Access Compliance Report Public Rights-of-Way (RR Crossings)

Intersection ID: 10025412	Main Street: E_CARSON_BV	Location: N/A
ADA ID: 7C8D19A596B4	Overall Compliance: No	Severity Score: 0.0
Codes/Mitigation Info/Possible Solution		Field Measurements/Component Compliance

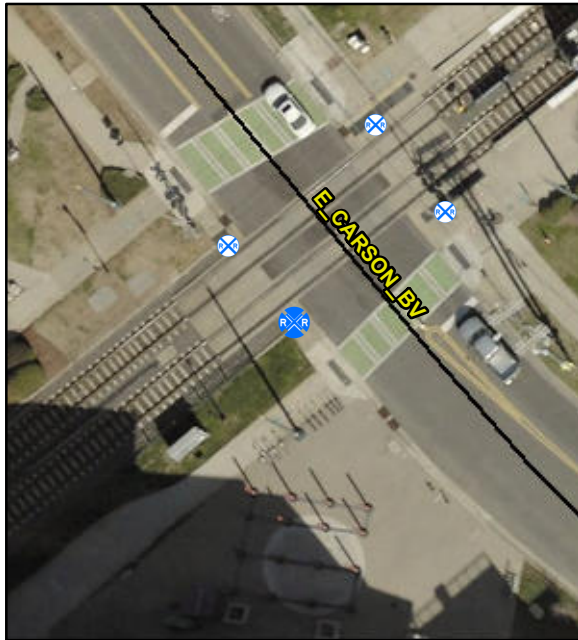
Remove & Replace Detectable Warning System. Provide Pedestrian Gate. Remove & Replace Walking Surface Adjacent to Rail.

R302.7.4, R305.2.5

Compliance	Description	Data
Yes	DWS Provided?	Yes
Yes	DWS Contrast?	Yes
Yes	DWS Width (in)	Yes
Yes	DWS Length (in)	36.0
No	DWS Offset (in)	29.0
No	Pedestrian Gate?	No
N/A	DWS Outside Gate?	No
N/A	Rail Type?	LightRail
No	Flangeway Gap (in)	3.0
Yes	Sidewalk Width (in)	58.0
